## Sheringham and Dudgeon (Windfarm) Extension Projects

### Perenco UK Limited Response to Examiner Deadline 1

Figure 1: Location of Waveney and Durango relative to DEP North

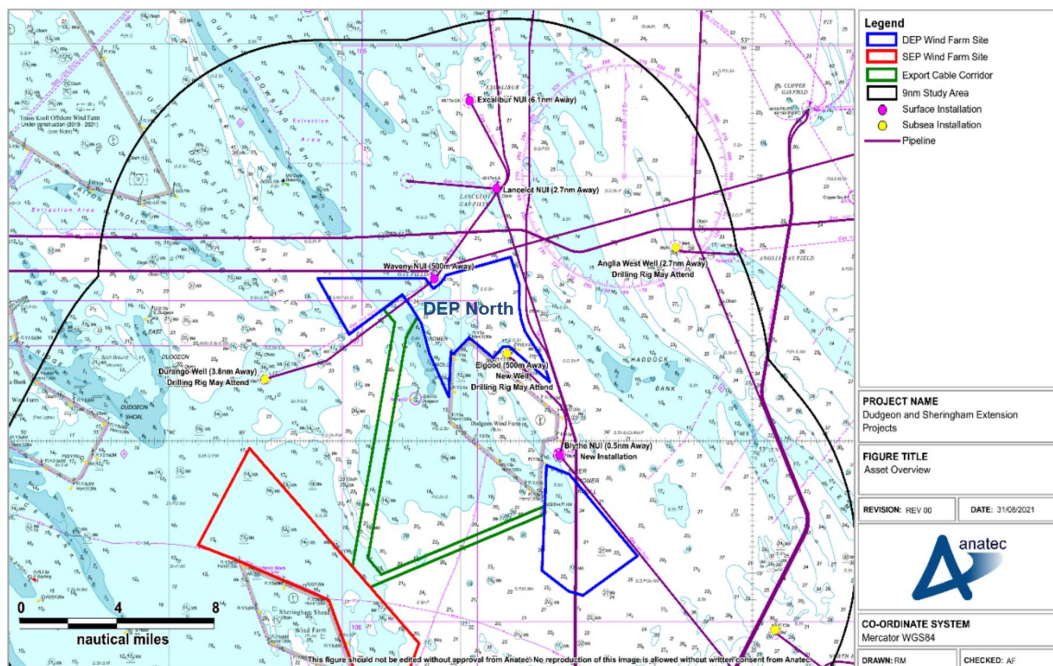
The Waveney NUI is located 500m from the northern edge of the proposed northern Dudgeon Extension Project (DEP North), whilst the Durango subsea wellhead is located to the southwest of the proposed DEP North development. The pipeline from the Durango subsea well to the Waveney NUI passes through the proposed windfarm array (Figure 1).

The Applicant commissioned Anatec to conduct a Vessel Access Study (APP-204). PUK believes that, if its proposals concerning space for helicopter operations are adopted, there would be no material restrictions to vessel operations around the Waveney NUI as long as no temporary or permanent surface infrastructure is placed within the 3nm (or even the 1.5nm) radius of the Waveney NUI. Space would also be required for marine operations along the pipeline between Durango and Waveney. A 1km wide corridor free from surface obstructions along the pipeline (500m either side) would suffice for this purpose.

- obstacle-free airspace of at least 3nm around the Waveney platform
- a corridor of at least 1km width along the route of the Durango to Waveney pipeline which is clear of temporary and permanent surface obstacles.
